APPENDIX E

Comment Letters Received on March 2009 and December 2009 Draft 10-Year Reviews

From: [Garcia, Dennis E SPA](#)
To: [Gilmore, Andrew F;](#)
cc: [Fitzner, April M SPA;](#)
Subject: RE: Trinidad Review Comment Period
Date: Tuesday, June 02, 2009 1:14:48 PM

Figure 1

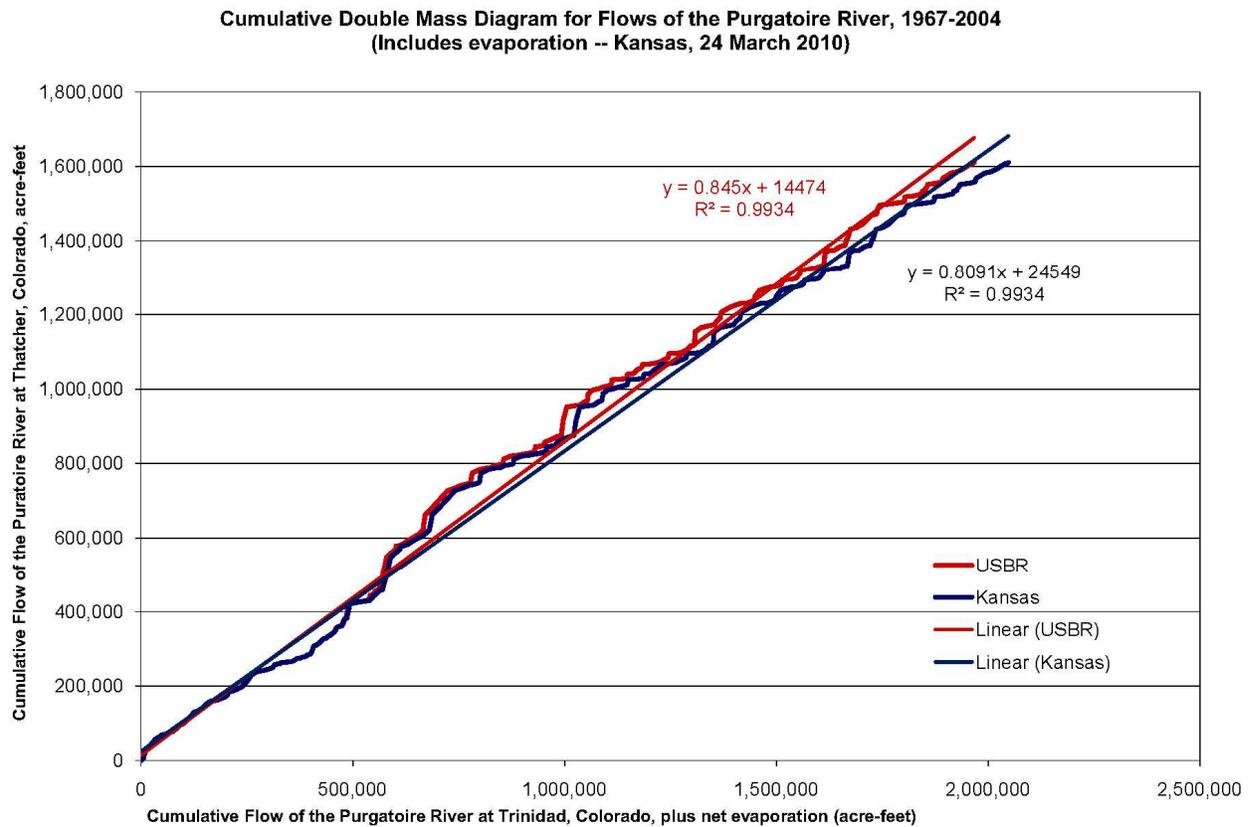
Reservoir Evaporation: The Appendix G table includes flow data for the Purgatoire River at Trinidad and Thatcher gages along with Trinidad Reservoir data: storage (content), change in storage and evaporation. It is good to have the reservoir information in this table to understand how the Purgatoire flows have been impacted. The storage information shows how the timing of the flows has changed due to the operation of the reservoir. The evaporation data provides water lost from the system due to the presence of the reservoir. Because the monthly evaporation represents lost stream flow, it should be accumulated along with the gaged flow for Purgatoire River at Trinidad. See Figure 1. By including the monthly evaporation, the slope and intercept of the trend line is changed.

Figure 2

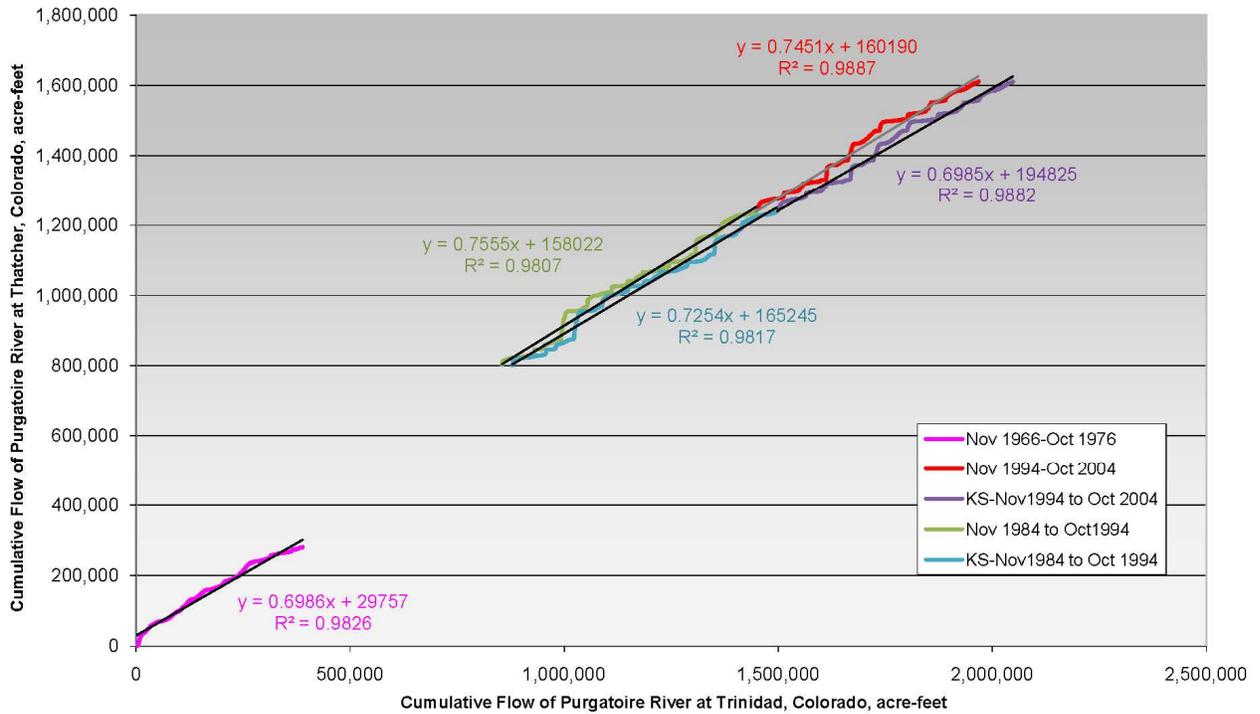
Recent Trend: The double mass analysis indicates a recent trend towards diminishing flows at Thatcher relative to flows at Trinidad. This may be more indicative of total hydrologic supply rather than the impact of the project itself. When evaporation is included as part of the accumulated flow through Trinidad, the slope of the line more closely matches the pre-project condition. See Figure 2.

This statement is not supported based on Figure 2, especially for the 1995 to 2004 period being reviewed. Figure 2 is similar to the graph which appears in Appendix G on page G-15. The differences are that each of the full 10-year review periods has separate trend lines and evaporation is included in the accumulated flow for Purgatoire River at Trinidad. Based on the backup data provided it was noted that the periods graphed on page G-15 starts in October 1984 and October 1994 rather than November 1984 and November 1994 as indicated.
